SEWAGE DISPOSAL TESTING

PROPERTY LOCATION: PATAPSCO OVERLOOK III

GRADING STUDY

LOT 43 SECTION 3
 "PATAPSCO OVERLOOK"
 4th ELECTION DISTRICT
 HOWARD COUNTY - MD.

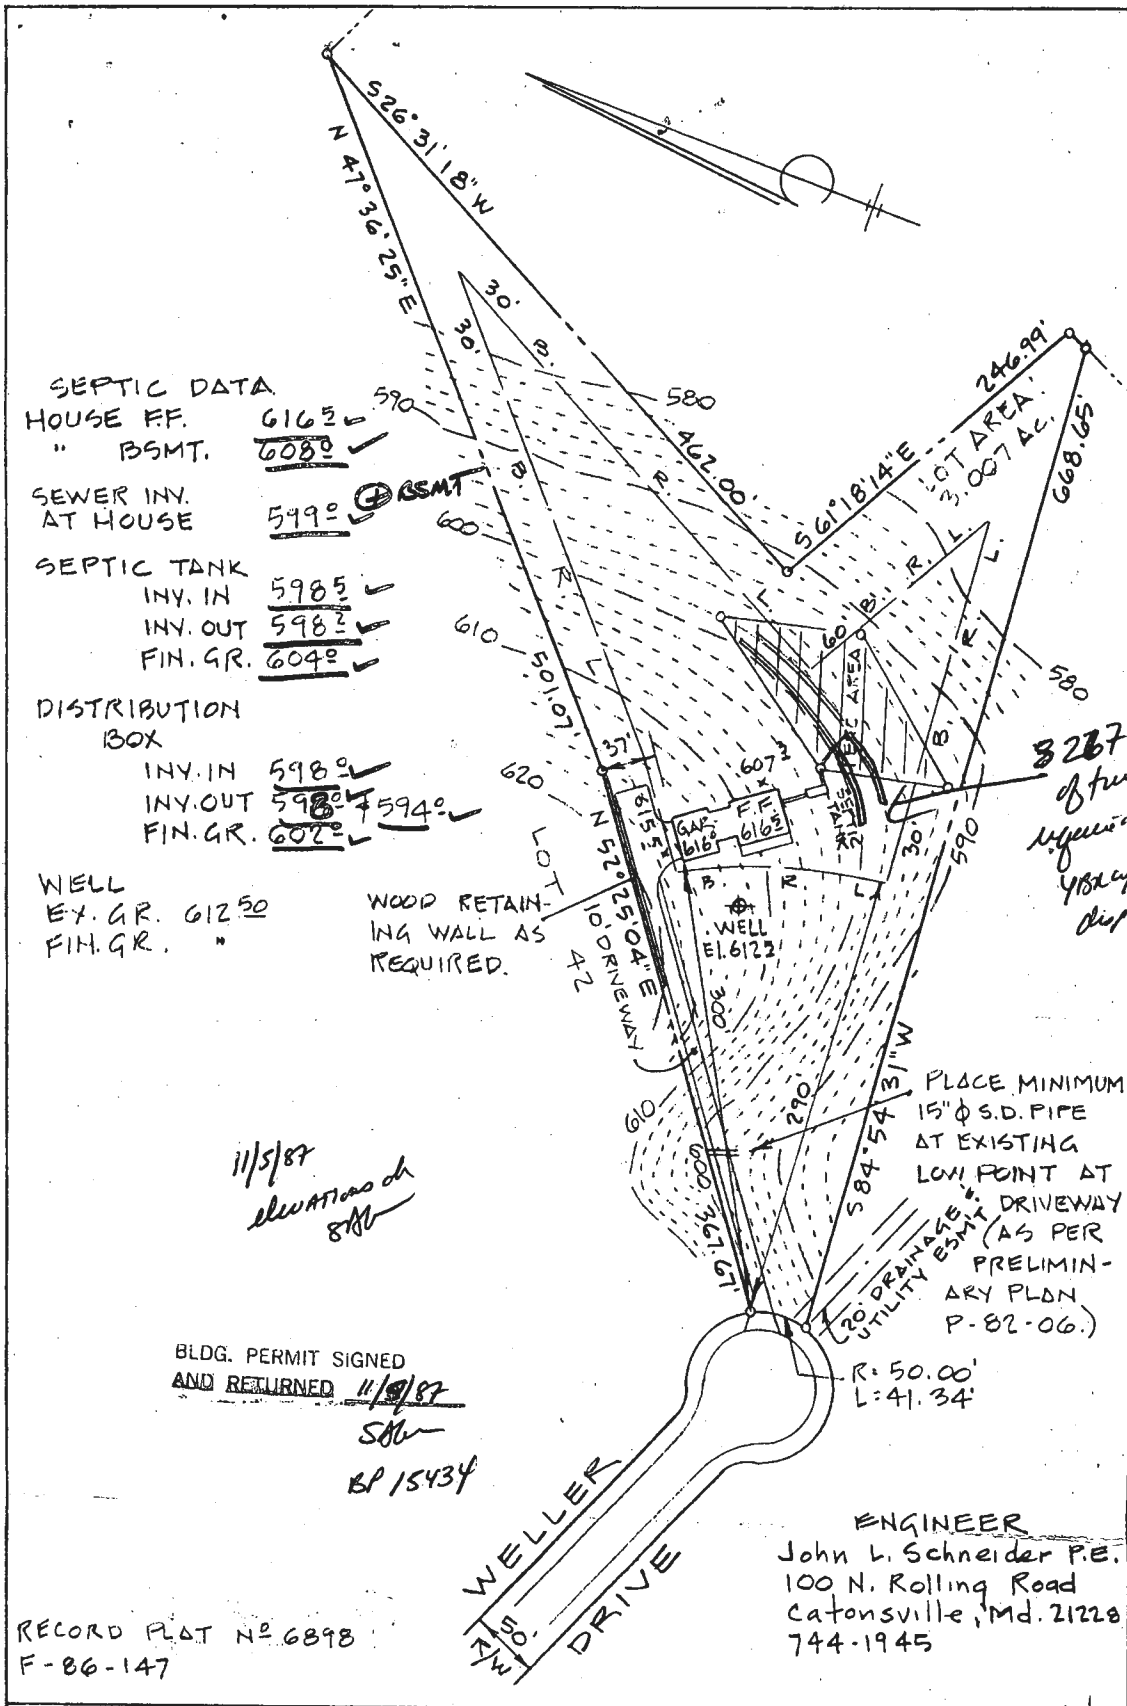
11/5/87 elevations ok SDB

PLACE MINIMUM 15" Ø S.D. PIPE AT EXISTING LOW POINT AT DRIVEWAY (AS PER PRELIMINARY PLAN P-82-06.)
